**PRESENTATION BY [REDACTED] CLARIFYING THE
FEBRUARY 15, 2001 REPORT BY EXPONENT, INC.
PRESENTED AT THE APRIL 27, 2001 MEETING WITH FEMA
IN COLUMBIA, SOUTH CAROLINA**

EXECUTIVE SUMMARY

CLARIFICATION

SLIDE 1

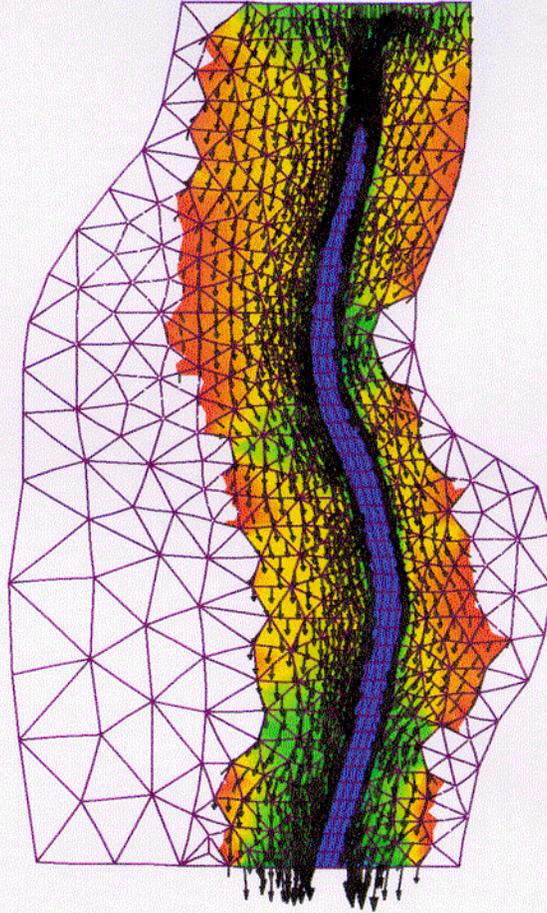
This is what a floodway looks like in a two-dimensional model. This is the river. This is the floodplain. Along this part of the floodplain the flow is unobstructed and the pattern, indicated by arrows, is parallel to the main river. In a floodway, the velocities are high. These white areas indicate low velocity and are not floodway. The most important characteristic of a floodway is that it eventually returns the water to the river.
